HADDAM NECK PLANT

CY-04-131

Haddam Neck Plant
License Amendment Request, Use of a Basement Fill Model (Revising the Buried
Debris Dose Model), and a Revision to Surface Contamination Release
Limits for Various Piping Sizes

Figure 3-1 ICI Sump Area

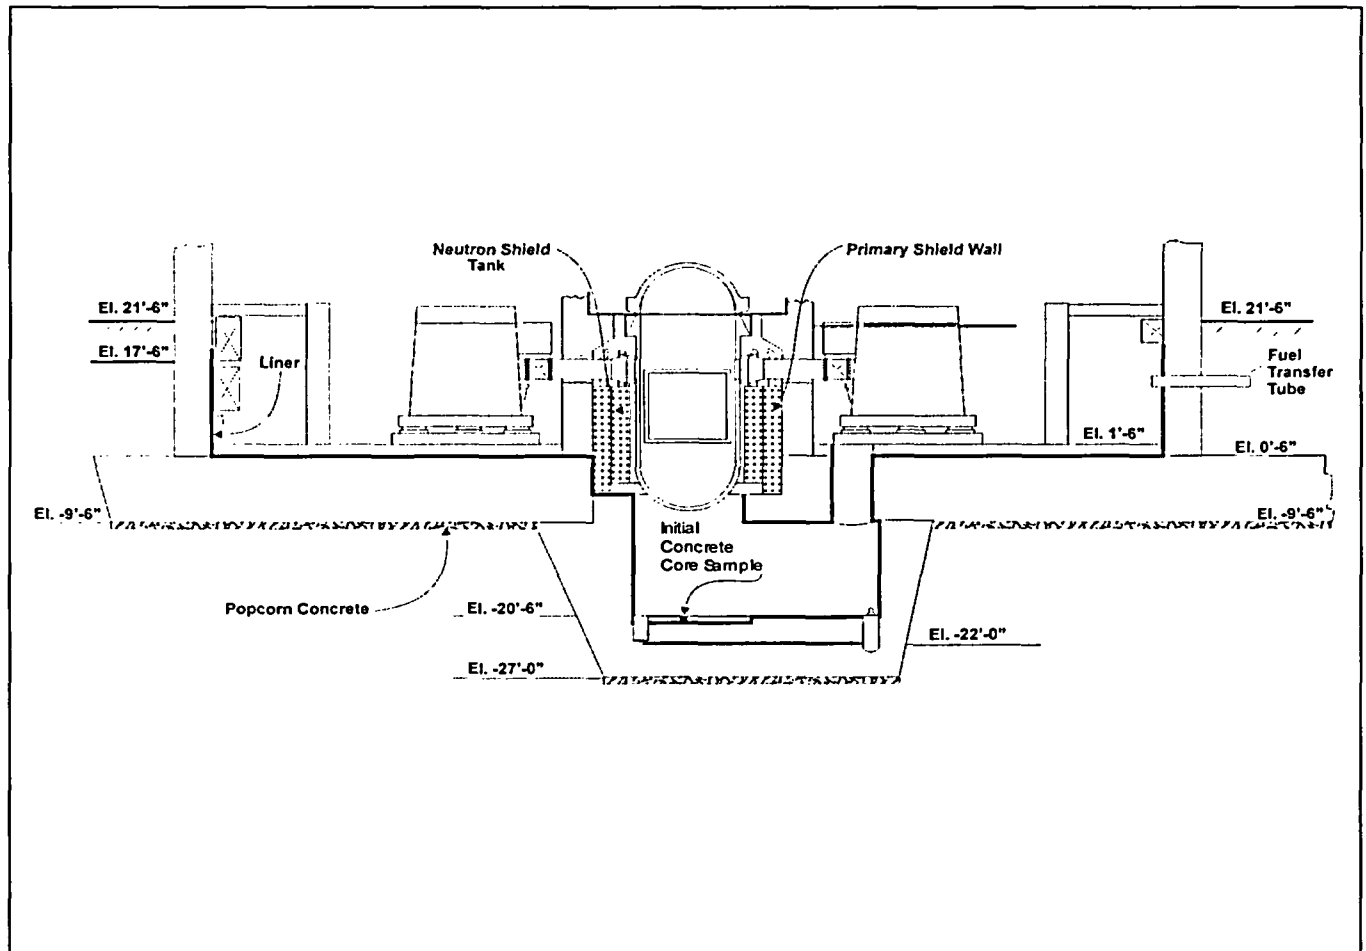
- a. The reactor pressure vessel (RPV) was enclosed and shielded by a combination of the primary shield wall and the ICI sump. The major arrangements of these structures are illustrated in Figure 3-1. The RPV is further shielded by the neutron shield tank (NST) which is supported inside the ICI sump.

- b. The ICI sump area is a right-circular cylinder, approximately 20 feet tall. The diameter is approximately 25 feet for the top 5 feet from elevation -0 feet, 6 inches to elevation -5 feet 6 inches. The ICI sump area diameter narrows to 16 feet for the remaining 15 feet of depth from elevation -5 feet 6 inches to elevation -20 feet 6 inches. The walls of the ICI sump vary in thickness but are a minimum of approximately 7 feet. The concrete mat below the steel liner of the ICI sump is 6 feet 6 inches thick.

- c. The containment's carbon steel liner is attached to the inside walls of the ICI sump. The liner is covered by the NST (and grout) from an elevation of -5' 6" to an elevation of -0' 6". The NST rested on a ledge in the ICI sump at elevation -5' 6". The walls (vertical sections) of the carbon steel liner are 3/8" thick; the floors (horizontal sections) are 1/4" thick. The ICI sump floor has approximately 1 foot of concrete on top of the liner, from elevation -20 feet 6 inches to elevation -19 feet 6 inches. On one side of the ICI sump, there is a horizontal tunnel (10' x 10') that provided access to the ICI sump area beneath the RPV. Figure 3-2 illustrates this arrangement, relative to the sump and RPV.

Figure 3-2 Detailed ICI Sump

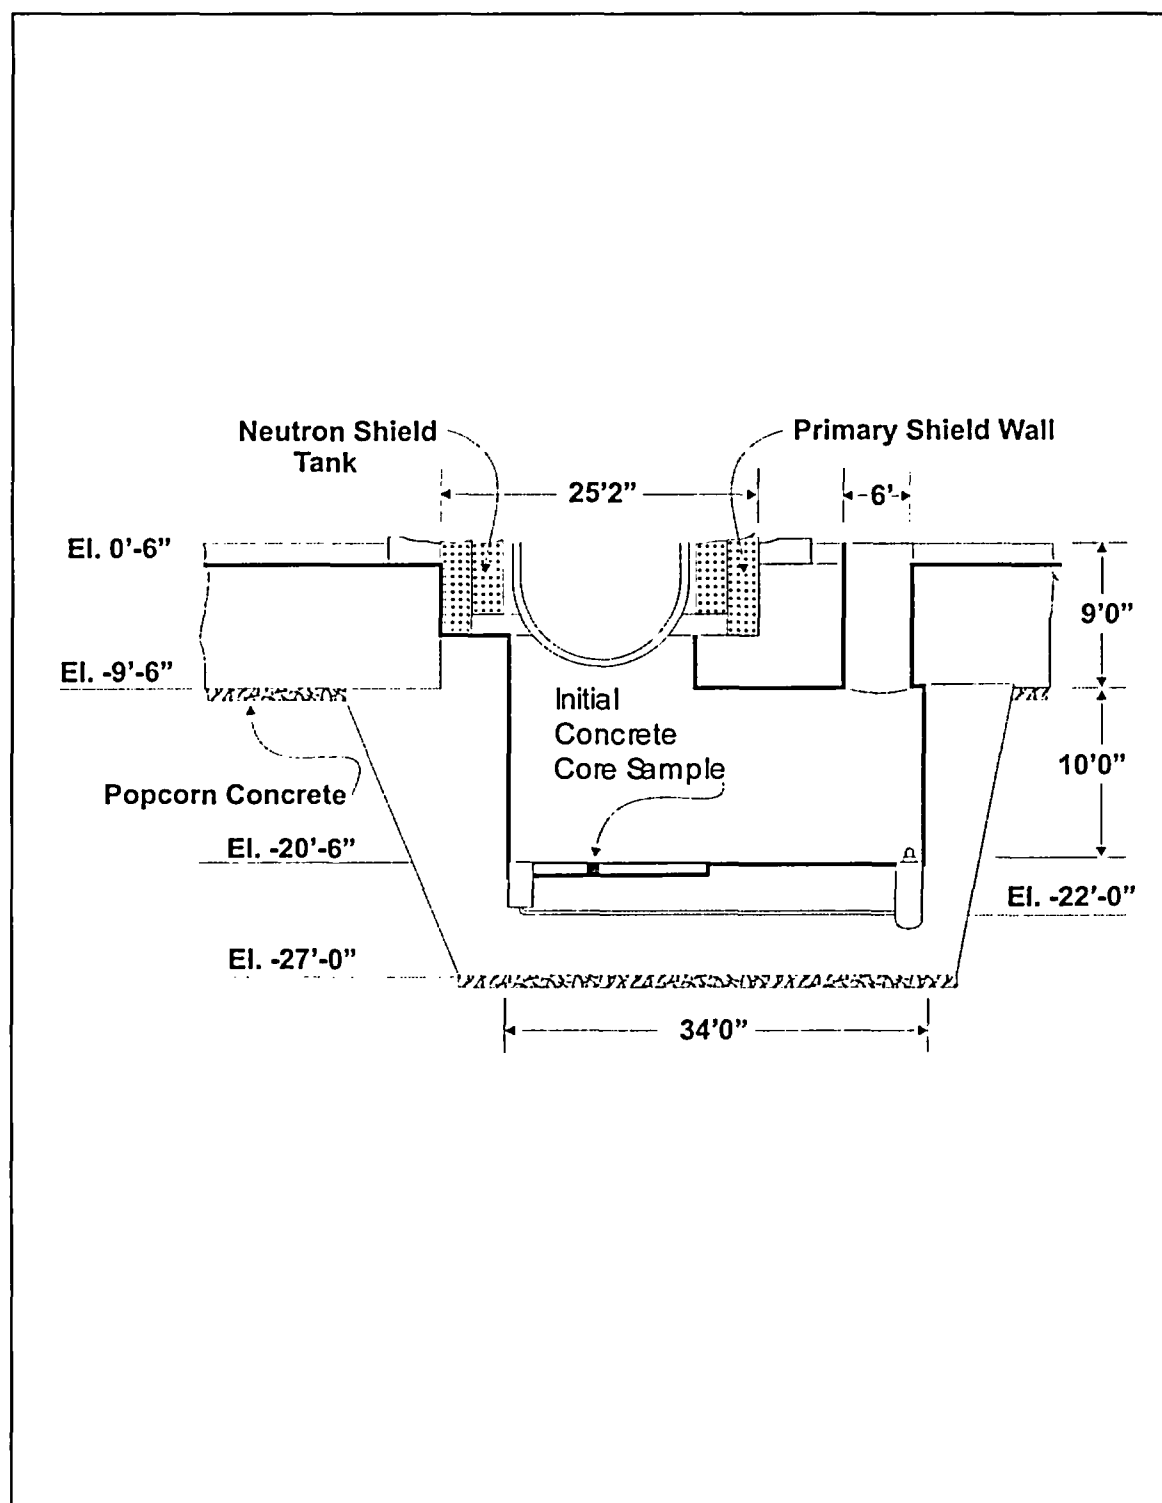
- d. The revised remediation plans include removal of all concrete in the containment, inside of the containment liner above elevation -20 feet 6 inches. Thus, the remaining concrete with significant activity from activation would be located in the ICI sump walls, behind the liner and below the liner floor elevation that corresponds with the bottom of the Neutron Shield Tank. See Figure 3-2.

The current LTP (Section 5.7.3.1.6) identifies activated concrete as a material for which some residual radioactivity would be left at the site. It was assumed that the activated concrete will be remediated to a value of the DCGLs developed throughout the relevant locations of the containment building. It was not anticipated that as much as two feet of concrete would need to be removed throughout the walls and floor of the ICI Sump as the characterization data to date appears to indicate (See Section 4.1 of this Attachment). CYAPCO had based its initial two feet expectation upon an activated concrete depth profile taken from a single concrete core bore to the containment liner at the expected highest flux location in the ICI sump floor (See Figure 3-2).

- One core eight inches deep was obtained from the floor area beneath the former location of the reactor vessel in the ICI sump as shown on Figure 3-2. This sample was taken to assess activation of concrete in this area. This core was cut into 8 – 1" wafers. Table 3 displays the radionuclide analysis results for these samples. These results show elevated concentrations for tritium, Fe-55, Co-60, Eu-152 and Eu-154 throughout the depth of the core. C-14, Cs-134 and Cs-137 were also detected in low levels but are believed due to surface contamination and are not expected below the liner in significant concentrations. For conservatism, these radionuclides have been included in the dose calculation. As shown in Table 3, the concentration of

The revised demolition strategy is to remove the interior below grade contaminated and activated concrete down to the containment liner. Thus, all containment building interior concrete above the elevation -20' 6" would be removed. The activated concrete on the floor of the ICI Sump would also be removed. This approach would leave the activated concrete behind the liner of the walls and floor of the ICI Sump, which is a change from the current LTP plan of remediating the activated concrete to the DCGL values.
